SUBJECT: **REVISION "B" TO ALERT SERVICE BULLETIN 407-04-63: (TAIL ROTOR DRIVESHAFT BEARING 407-340-339-101, REPLACEMENT OF)**

Revision "B" to this Alert service bulletin introduces the increase of the lubrication and the inspection interval from 100 hours to 300 hours of operation applicable to tail rotor driveshaft bearing 407-340-339-107.

NO. 407-04-63

SUBJECT: TAIL ROTOR DRIVESHAFT BEARING 407-340-339-101/-103, REPLACEMENT OF

Figure 1. Decal location of blower area

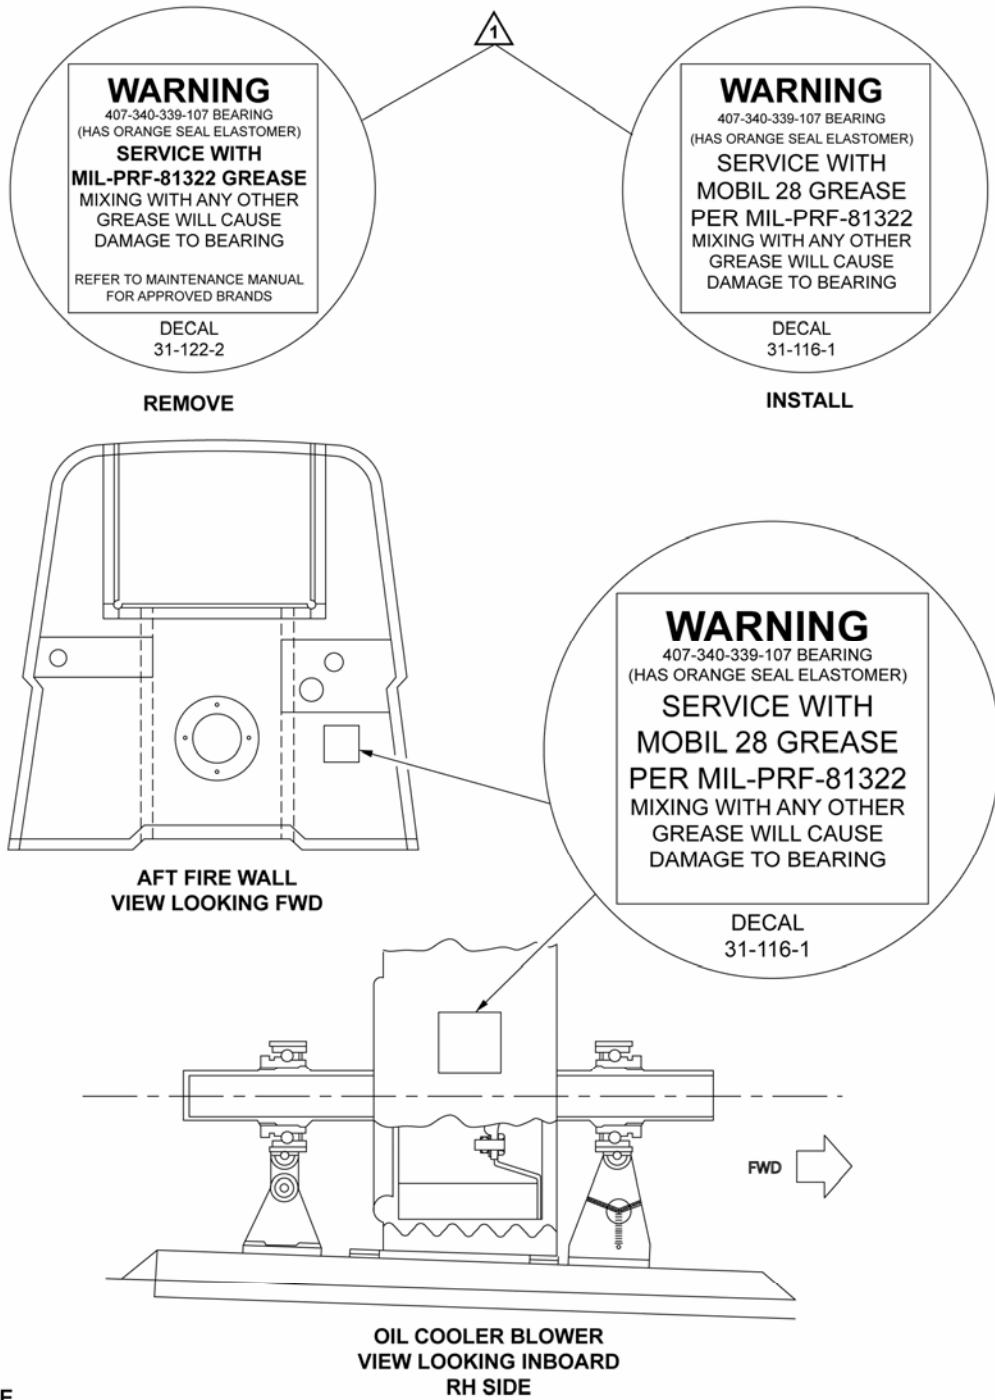
4. Lubricate the installed bearings with grease, Mobil 28 (MIL-PRF-81322) (PART V of this bulletin).
5. Install the decals 31-116-1 (Figure 1) and apply polyurethane paint sealer, MILC85285TY1,CLEAR (C-245) with a paint brush to protect the decals.
6. Do an operational test (BHT-407-MM-7, Chapter 65).
7. Install cowling (BHT-407-MM-7, Chapter 53).
8. Make an entry in the helicopter technical records to show that PART I of this Alert Service Bulletin is completed.

1 Decal 31-112-2 shall be replaced by decal 31-116-1.

1. Remove the tail rotor driveshaft and the aft fairing assembly (BHT-407-MM, Chapter 53).
2. Remove the warning lubrication decals 31-112-2 (NOTE 1, Figure 1 and 2).
3. Install decals 31-116-1 (Figure 1 and 2) and apply paint sealer, MILC85285TY1,CLEAR (C-245) with a paint brush to protect the decals.
4. Re-install the tail rotor driveshaft and the aft fairing assembly (BHT-407-MM, Chapter 53).
5. Make an entry in the helicopter Technical Records to show that PART III of this Alert Service Bulletin is completed

Figure 2. Decal location of tailboom area

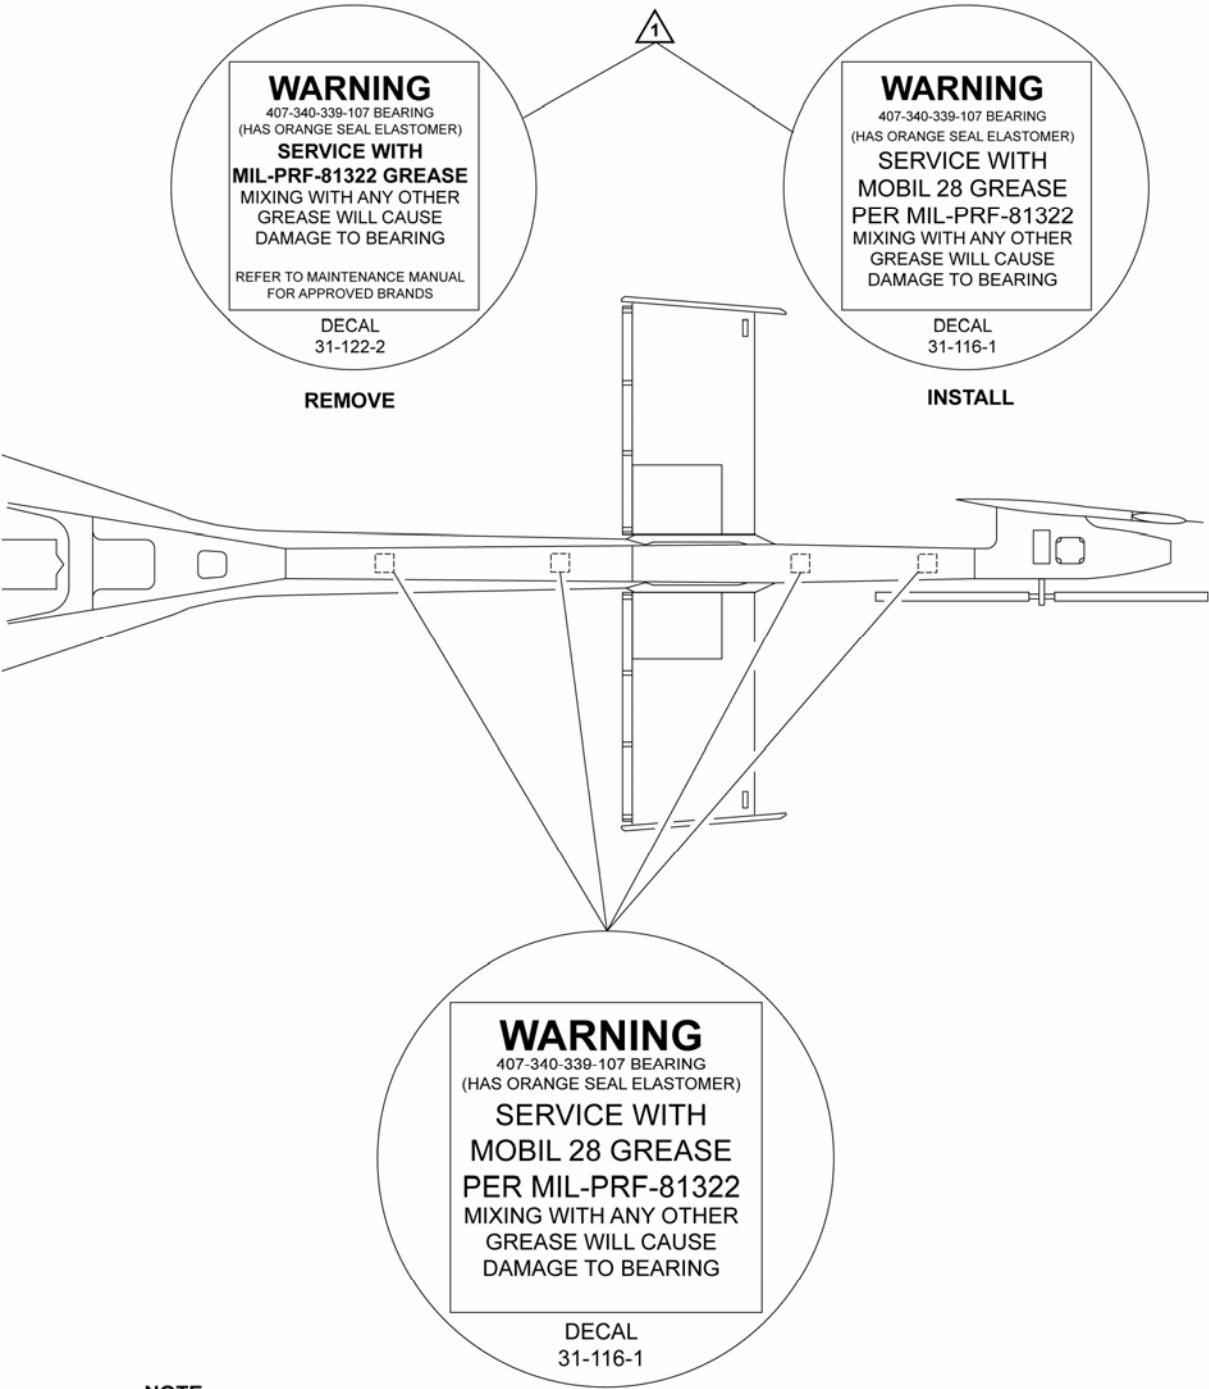
1. Remove the segmented shaft bearing 407-340-339-101 or /-103 (BHT-407-MM-7, Chapter 65).
2. Install bearing, 407-340-339-107 (BHT-407-MM-7, Chapter 65).
3. Install decals 31-116-1 (Figure 2) and apply a paint sealer, MILC85285TY1,CLEAR (C-245) with a paint brush to protect the decals.
